**BYTEK VW Expansion Project**  
**1325 St. Laurent Blvd.**  
**Ottawa, Ontario**  
**Our Ref: 2301**

## **Post Tender Addendum N° 2**

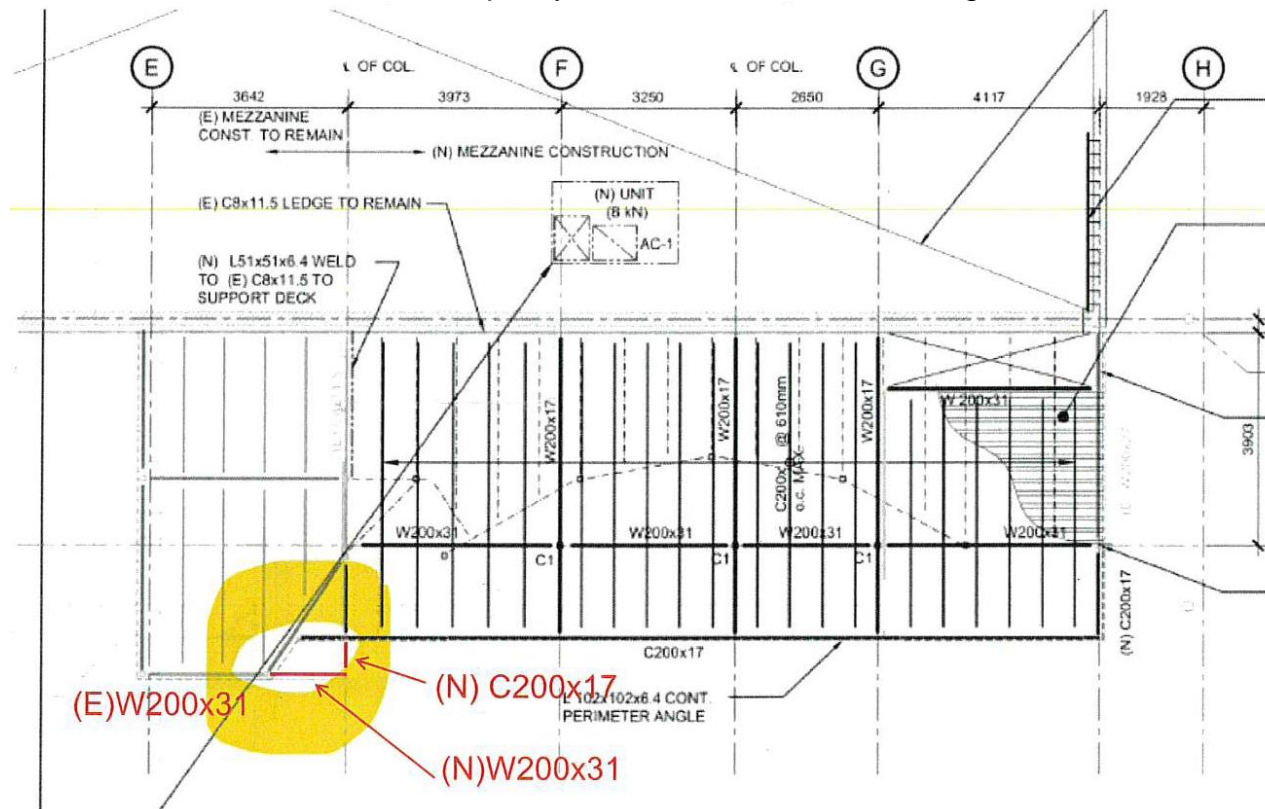
54. Structural Drawings Rev 3, and Arch drawing A102 Rev 2 accurately depict the East addition in terms of overall dimension of 17700mm from Gridline A to D.
